Ketchikan Bridge Project Summary Report

KETCHIKAN BRIDGE PROJECT PORT OF KETCHIKAN, ALASKA TONGASS NARROWS

SUMMARY REPORT

Figure 1 - Location of Proposed Bridge Sites F1 and F3 in East and West Channels

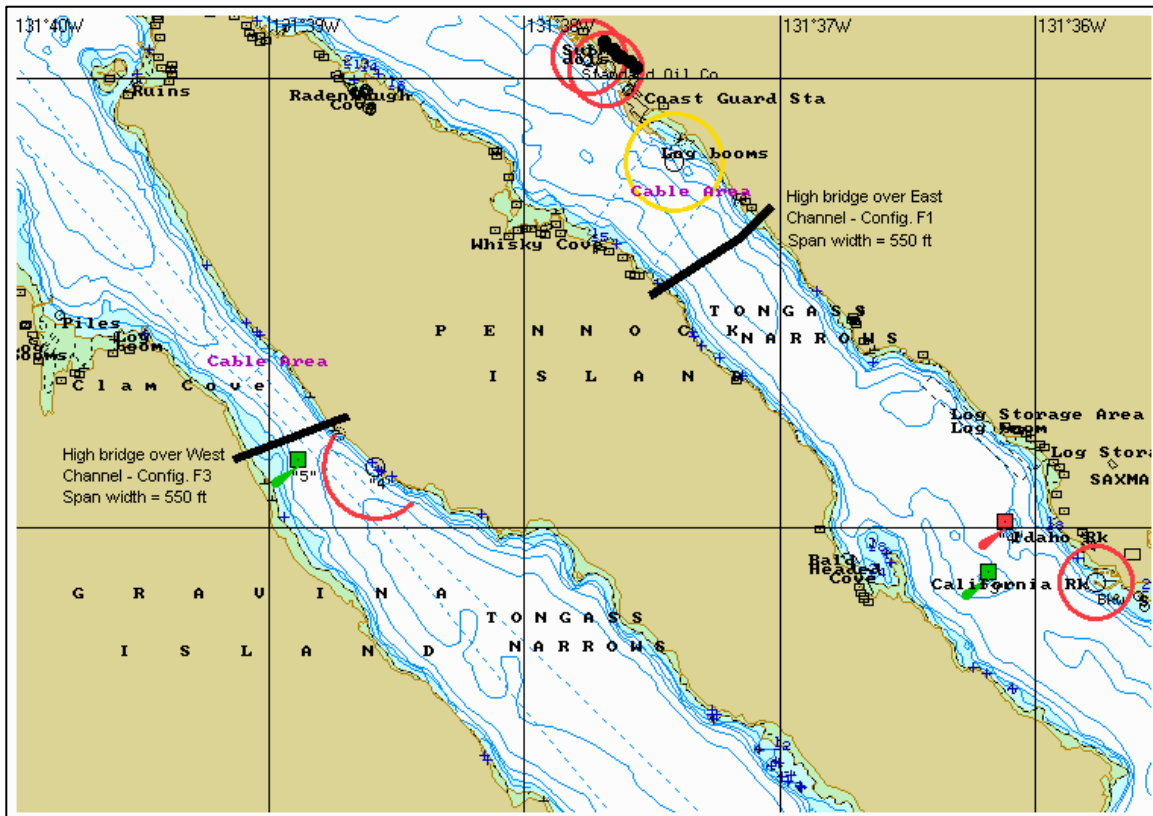
The channel becomes very narrow at the location of the proposed bridge site due primarily to a shoal area on the western shore. For this reason, the pilots indicated that large cruise vessels do not traverse this channel as a rule, although it is suitable for smaller vessel traffic.

The proposed position of the bridge with support stanchions on the shoal area is characterized by the bridge span crossing the channel at an oblique angle (approximately 25 degrees). As a result, the bridge span in West Channel is not perpendicular to the centerline of the navigation channel and the center of the span is not aligned with the center of the channel. In the simulated southbound runs, the vessels were routinely maneuvered close to the shore of Pennock Island, which has a steeply inclined bank, in order to align properly for the bridge transit. The vessels passed through the bridge opening at a rather high speed for such restricted waters. This speed was necessary in order to maintain good directional control with the fair current, as well as to minimize any ‘crab angle’ that would be necessary to counter the effect of the moderate to high wind conditions that were simulated.

1. According to the pilots, the West Channel is considered unsafe for transits by any large cruise ships without a bridge (present condition). They believe that this route should only be considered for the low bridge option or (better) no bridge at all. They offered the following reasons:

- Current set due to the shoal area on the Gravina Island side (at the proposed bridge location) is toward Pennock Island at the constriction. The narrow channel provides insufficient width to carry much of a ‘crab angle’ to counter this set. This is also true when wind is on the quarter or on the bow, causing leeway which must be corrected by carrying a substantial ‘crab angle’. The pilots believe that a limit of 20 knots of wind may be the operational limit for large cruise ships in this channel, due to narrowing of the waterway at the bridge site.

- The pilots stated that they could not safely take a large vessel through this channel due to its narrow constriction and the current set toward Pennock Island in the vicinity of the shoal area near the proposed bridge site. Only one ship’s width is available to either side at the narrowest point of the channel. There would be no margin for error at the bridge: e.g., a gust of wind, engineering casualty, error in responding to helm commands, opposing traffic, etc., would allow very little time to react and correct.

- Although not tested, the pilots' recommended that the bridge span should be increased another 100 to 150 feet.
- Construct the bridge so that the navigable span is perpendicular to the channel trackline, and the span itself should be centered about the navigable channel. The oblique angle of the bridge with the channel that was simulated has the effect of reducing further the narrow opening. This caused the pilot to alter course quickly just before the bridge to steer the vessel straight through the span, followed by a second alteration upon leaving the bridge opening to rejoin the normal trackline.

Should a bridge be constructed in the East Channel, it is recommended that the cables presently located near this site, be raised from the bottom and run along the bridge, or otherwise relocated. This would facilitate the use of anchors in an emergency without risk to the cables. Other recommendations include:

- Although not tested, the pilots' recommended that the bridge span should be increased another 100 to 150 feet.
- Construct the bridge so that the navigable span is perpendicular to the channel trackline, and the span itself should be centered about the navigable channel.
- Since the narrowest section of the East Channel is between California and Idaho Rocks, consideration should be given to the removal of one (Idaho) or both of these hazards to navigation.

Figure 2 – Location of Proposed Bridge Site C4 at North Channel

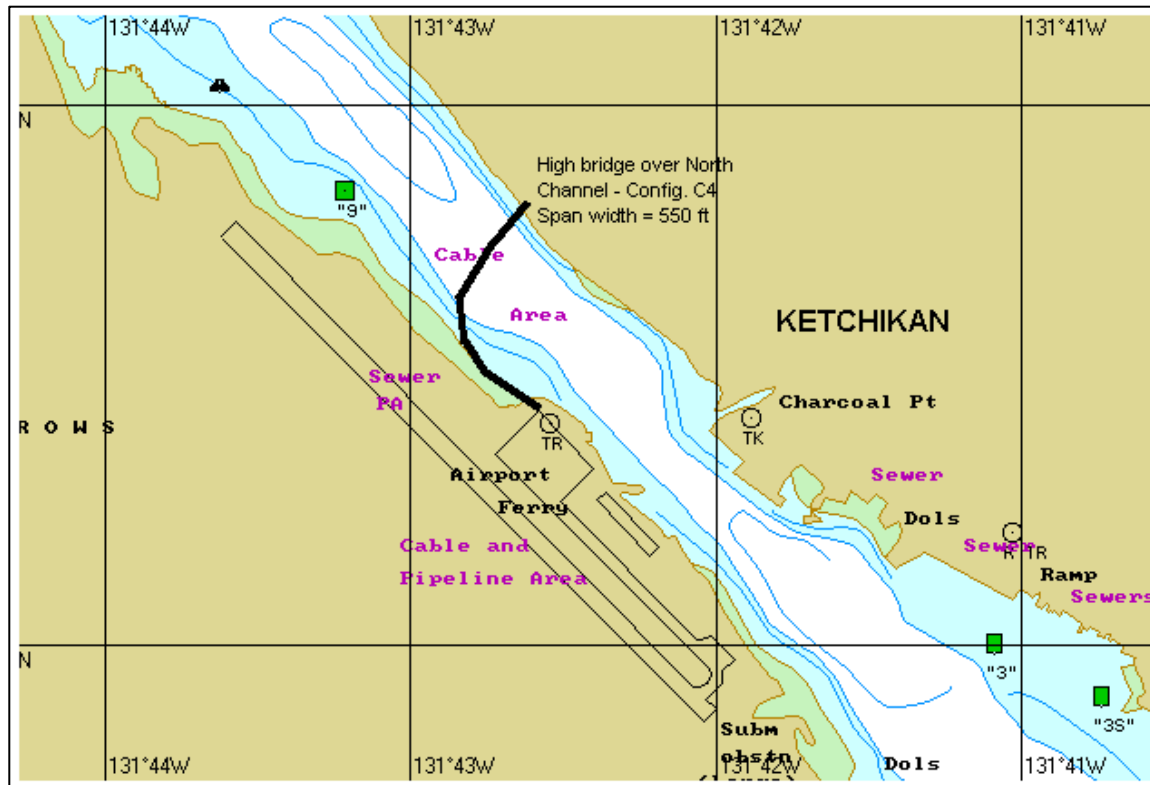
The participants made comment on the fact that the location of the bridge opening is shifted to the southwest from the normal trackline in the channel. Traversing the bridge opening requires a ‘jog’ in the ship’s normal course in order to negotiate the span. Furthermore, the bridge at this site was not perpendicular to the vessel trackline (approximately 20 degrees). This has the effect of further reducing the usable span width.

1. Although not tested, the pilots' recommended that the bridge span should be increased another 100 to 150 feet.
2. Construct the bridge so that the navigable span is perpendicular to the channel trackline, and the span itself should be centered about the navigable channel.

Figure 3 – Hazards Requiring Removal or Navigation Aids

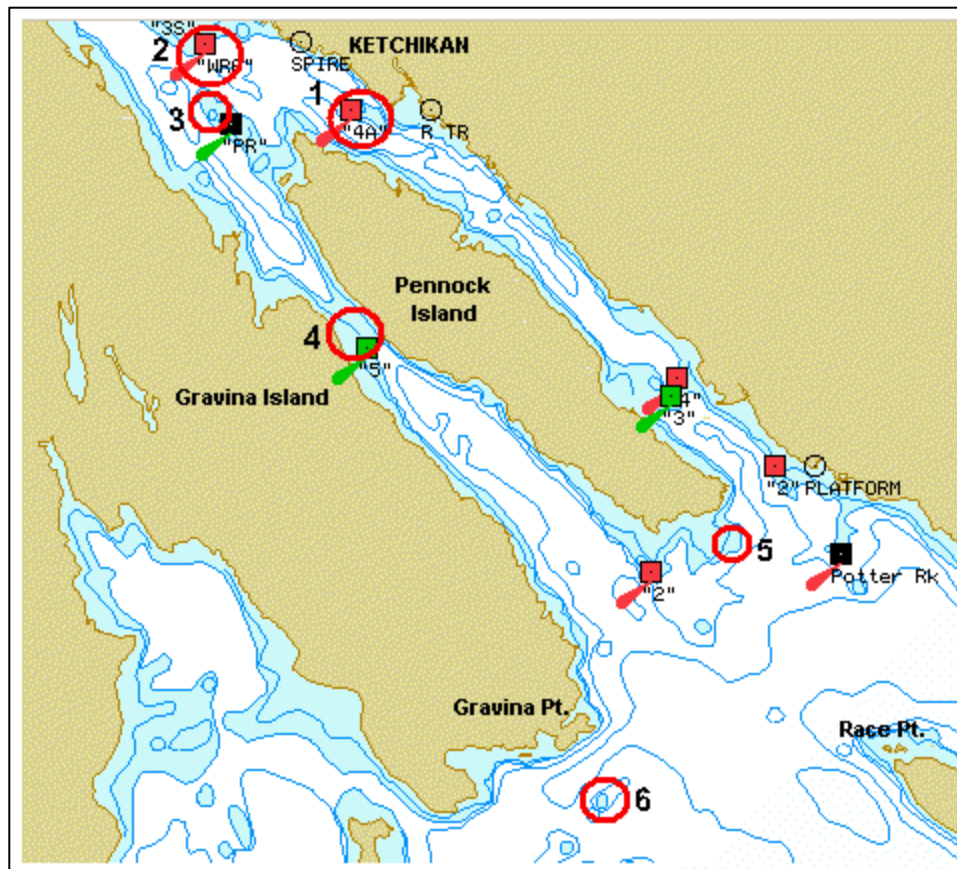
The removal of obstructions and Navigational aids (see Fig 3), is not necessarily directly related to proposed bridge locations, but is examined as a collateral issue. Several exercises were conducted to examine how the berth approach or departure would be affected by the removal of several known obstructions. The removal of the wreck and its buoy (“WR6”) may make it easier to maneuver through the anchorage enroute to or from the berth, particularly if another cruise ship is anchored there.

It is readily apparent to observers that the removal of the shoal and buoy “4A” located just off the passenger ship dock will significantly improve the safety of berthing operations at the dock, as well as of arrival and departure maneuvers near the dock. The track plots show different strategies were used to and from the berth in the absence of these hazards.

Other recommendations that were supported include (see Figure 3):

- (1) Remove the shoal off the passenger ship berth and its buoy "4A".
- (2) Remove the wreck and wreck buoy "WR6".
- (3) Remove the 5-fathom hump northwest of the Pennock Reef buoy "PR" or mark it with an appropriate aid to navigation.
- (4) Remove the shoal area on the Gravina Island side of the West Channel, if West Channel becomes the main navigational channel with construction of the high bridge at the proposed location.
- (5) Add a buoy to mark the extent of the shoal area at the south end of Pennock Island across from Potter Rock.
- (6) Remove the 5-fathom rock near Gravina Point in Nichols Passage or mark it with an appropriate aid to navigation.
